Access Compliance Report

Public Rights-of-Way

(Curb Ramps)

Intersection ID: 10034400	Main Street: PIEDMONT_PARK_DR	Cross Street: AUDUBON_PARK_DR	Location: W
ADA ID: E6FCA9F5BF82	Ramp Type: Directional1	Initial Pass/Fail: Fail	Overall Compliance: No
		Severity Score: 12.5

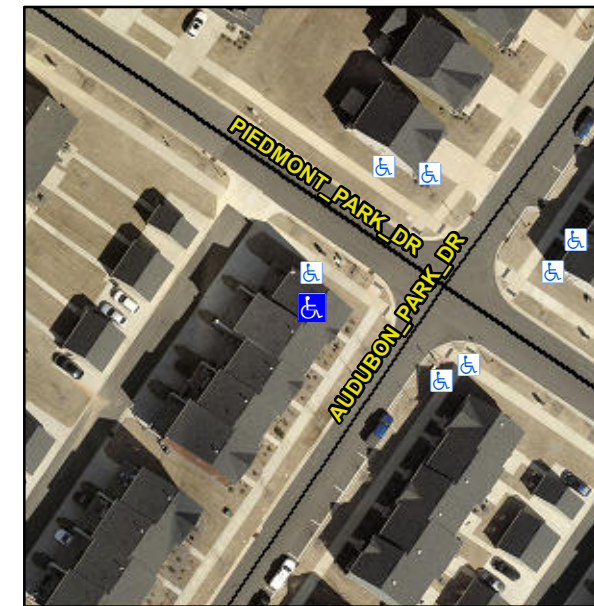
R304.2.2

Compliance	Description	Data	Compliance	Description	Data
N/A	Ramp Length (in)	43.0	N/A	Grade Break?	N/A
Yes	Ramp Width (in)	72.0	N/A	Grade Break Slope (%)	0.0
No	Ramp Slope (%)	9.6	N/A	Grade Break XSlope (%)	0.0
Yes	Ramp XSlope (%)	0.8			
N/A	Flare Type LT	N/A	N/A	Flare Type RT	N/A
N/A	Flare Slope LT (%)	N/A	N/A	Flare Slope RT (%)	0.0
N/A	Flare Traversable LT?	N/A	N/A	Flare Traversable RT?	N/A
N/A	Landing Length (in)	0.0	N/A	DWS Provided?	N/A
N/A	Landing Width (in)	0.0	N/A	DWS Contrast?	N/A
N/A	Landing Slope (%)	0.0	N/A	DWS Length (in)	N/A
N/A	Landing X Slope (%)	0.0	N/A	DWS Full Width?	N/A
N/A	Landing Curb? (Y/N)	N/A	N/A	DWS Offset LT (in)	N/A
N/A	Shared Landing?	N/A	N/A	DWS Offset RT (in)	N/A
N/A	Gutter Ponding?	0.0	N/A	Gutter Slope (%)	N/A
N/A	Gutter Lip Ht (in)	0.0	N/A	Gutter X Slope (%)	N/A
N/A	Painted X Walk1?	No		Road Slope (%)	2.2
	X Walk 1 Direction	To SE		Road X Slope (%)	3.2
	X Walk 1 Width (in)	N/A		Clear Space?	N/A

Remove & Replace Entire Ramp.
